Subject: AP1000 Response to Request for Additional Information (TR44)

Westinghouse is submitting responses to the NRC request for additional information (RAI) on SRP Section TR44. These RAI responses are submitted in support of the AP1000 Design Certification Amendment Application (Docket No. 52-006). The information included in these responses are generic and is expected to apply to all COL applications referencing the AP1000 Design Certification and the AP1000 Design Certification Amendment Application.

Response to Request for Additional Information on SRP Section TR44

Figure 44-2.1 Stress Strain Curve for SA240-304 Stainless Steel

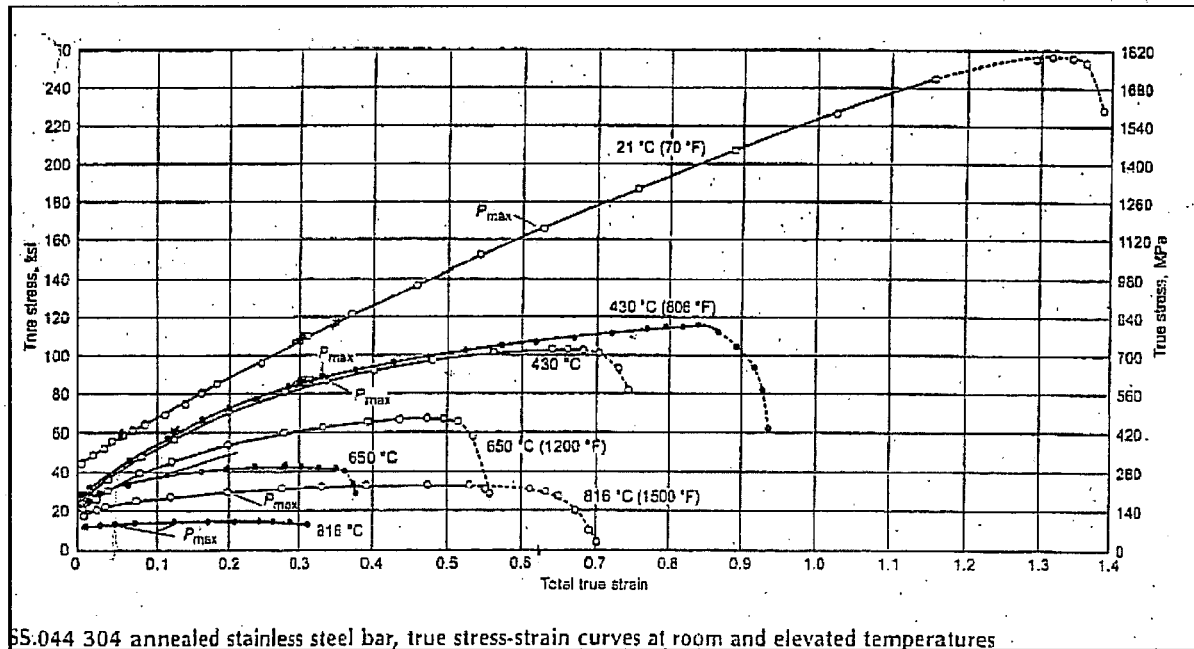
Section 2.8.5 states that appropriate non-linear material properties have been applied to the rack components to permit yielding and permanent deformation. Table 2-6 only provides Young's modulus, yield strength, and ultimate strength, which are not sufficient to define an engineering stress-strain curve. In addition, LYDYNA requires true stress-strain relation for its nonlinear materials. Therefore, provide the following: (1) a complete description of the material stress-strain curve and confirm that a true stress-strain curve was used in these impact analyses and (2) a description of the fuel assembly model, including the element properties and material properties for the dropped fuel assembly.

1) The new fuel racks are fabricated from SA240-304 and SA564-630 stainless steel. For the impact analyses, a true-stress strain curve, which is obtained from Atlas of Stress Strain Curves (2nd Edition, ASM International) and reproduced below as Figure TR44-2.1, is used to define the strength properties of SA240-304 stainless steel.

Figure 2-8 LS-DYNA Model of Dropped Fuel Assembly

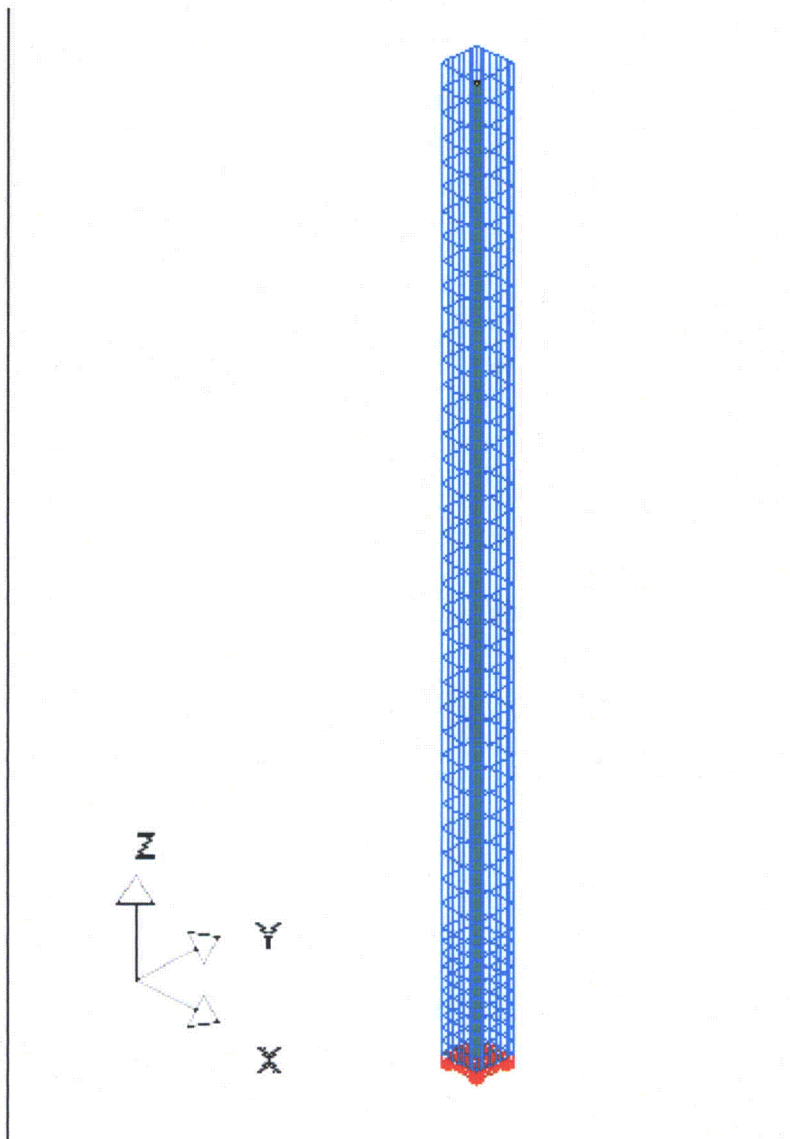
The baseplate in Figure 2-8 appears to have only one layer of 8 node brick element through its thickness. It is not clear if a solid or a thick shell element is used. Clarify the type of element used for the baseplate.

(2) For spent fuel rack RAI-TR54-05, Section 2.8.5 of TR54, Rev. 1 was revised to include a more complete description of the fuel assembly model. The staff reviewed Rev. 1 of TR-54 (Section 2.8.5) and found that the stiffness and mass representation is acceptable, and this item was resolved in the May 21 and 22, 2008 technical review. For the new fuel racks, Section 2.8.5 of TR44 was revised to include the equivalent information; see the Technical Report Revision section.

Both analyses are performed using the dynamic simulation code LS-DYNA (Reference 22). A finite element model of one-quarter of the AP1000 New Fuel Storage Rack plus a single fuel assembly is modeled using appropriate shell and solid body elements available in LS-DYNA. The fuel assembly model, which is shown in Figure 2-8, consists of four parts: a rigid bottom end fitting, an elastic beam representing the fuel rods, a lumped mass at the top end of the beam representing the handling tool, and a thin rigid shell that defines the enveloping size and shape of the fuel assembly. The mass and cross-sectional area properties of the elastic beam are based on the entire array of fuel rods (cladding material only). The fuel mass is lumped with the bottom end fitting. Appropriate non-linear material properties have been assigned to the rack components to permit yielding and permanent deformation to occur. Figure 2-9 shows the details of the finite element model in the area where the impacts occur.

Figure 2-8 was added to TR44:

Figure TR44-05.1 Fuel Assembly Deep Drop Scenario 1 for New Fuel Rack

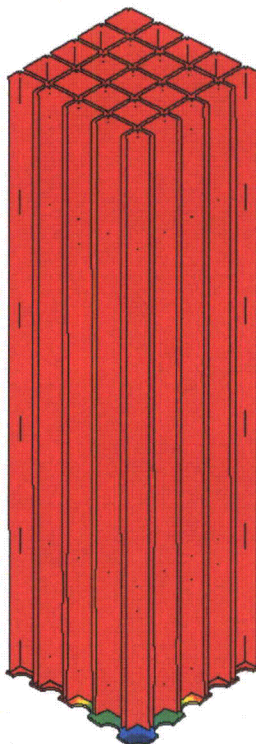
Section 2.8.5 does not indicate whether other fuel assemblies are in place, when a fuel assembly drops through an empty cell and impacts the baseplate at its center. Depending on how the baseplate is designed, a full load of fuel assemblies may introduce progressive deformation after a fuel assembly impacts at the center of the baseplate. The maximum downward deformation of the baseplate is about 3.8 inches, as shown in Figure 2-10. This may be significant enough to initiate a progressive deformation. Therefore, provide: (1) the assumption on the existing fuel assemblies when the impact occurs, (2) the design basis for the baseplate, and (3) a figure similar to Figure 2-10, that shows the cells together with the severely deformed baseplate.

- (3) Figure TR44-005.1 below shows the cells together with the severely deformed baseplate for the same LS-DYNA solution as shown in Figure 2-10. Note that the deformation of the cells is not significant compared to the baseplate. This is because the cell-to-baseplate weld connections break as a result of the postulated fuel impact load before the cell walls are permanently deformed.

Figure 2-9 Results from Drop on AP1000 New Fuel Storage Rack

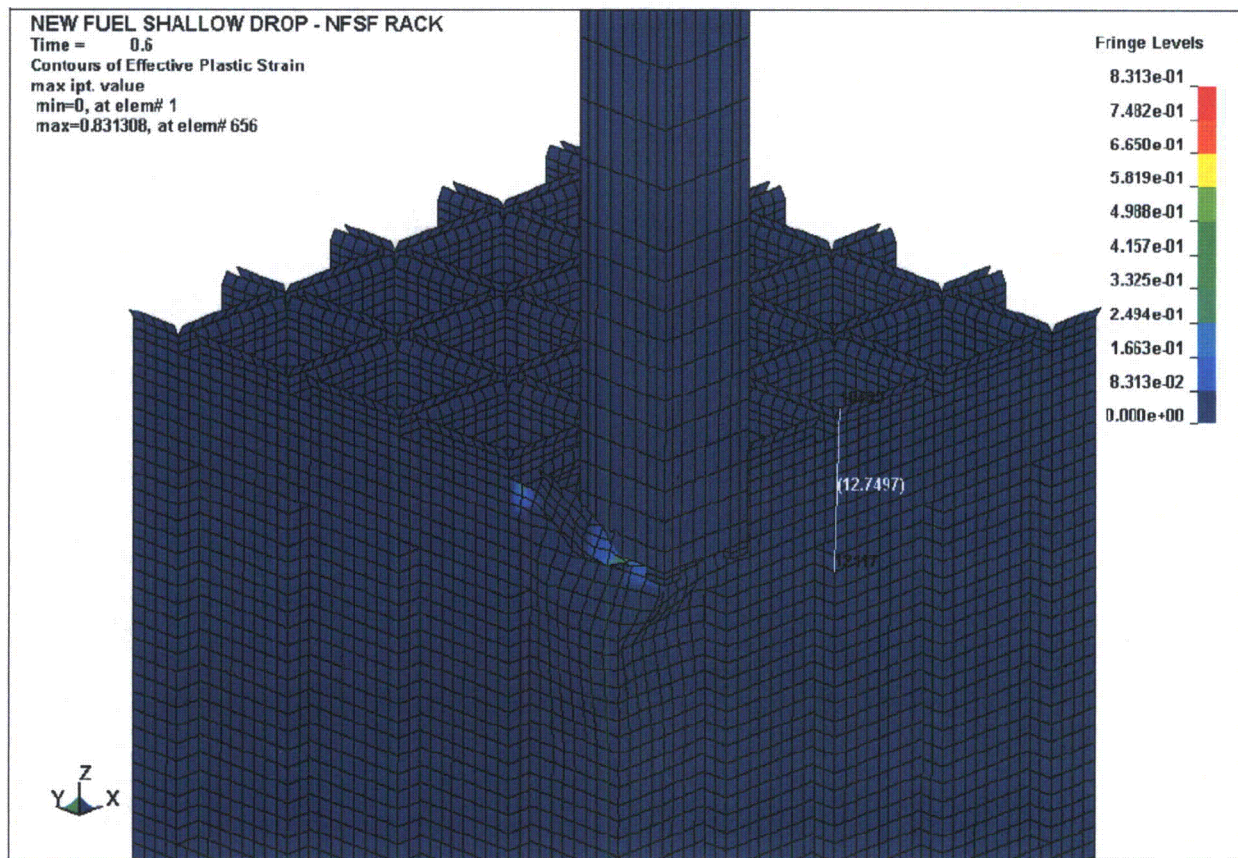
Figure 2-9 of this report shows the permanent deformation at the top of a cell wall. The permanent deformation is measured as 10.26 inches, which is smaller than the limit of 14 inches. However, the figure also shows indications of nontrivial hourglassing, which may significantly affect the accuracy of the analysis result. The mesh at the impact location should be locally refined, to ensure convergence with mesh size. Therefore, an additional analysis with a finer mesh at the impact region should be performed to confirm that the model is suitable.

The 36" fuel assembly drop onto the top of the new fuel rack was re-analyzed in Revision 1 of APP-FS02-Z0C-001, "Analysis of AP1000 Fuel Storage Racks Subjected to Fuel Drop Accidents", with consideration of strain rate effects for the welds. The new analysis shows that the maximum permanent deformation of the rack cell wall is 12.75" (measured from the top of rack) versus the allowable limit of 20.83". This allowable limit is the distance from the top of the rack to the top of the poison panel, which is 2 inches above the top of the active fuel. Note the height of the new fuel rack cell was increased by 6 inches. Since the active fuel region is surrounded by an undamaged cell wall, there is no longer a need to demonstrate that the refinement of the model is adequate in the localized region of the impact zone.

The results from the analyses are shown in Figures 2-9 and 2-10. For the drop to the top of the AP1000 New Fuel Storage Rack, the extent of the permanent damage is limited to a depth of 12.75 inches. The tops of the poison panels are located 20.83 inches below the top of the rack. The poison panels overlap the active fuel by two inches at the top and bottom. The top of the active fuel begins 22.83 inches below the top of the rack, therefore, the active fuel region is surrounded by an undamaged cell wall and no further criticality analysis is required.

Figure 2-9 was replaced with the following figure:
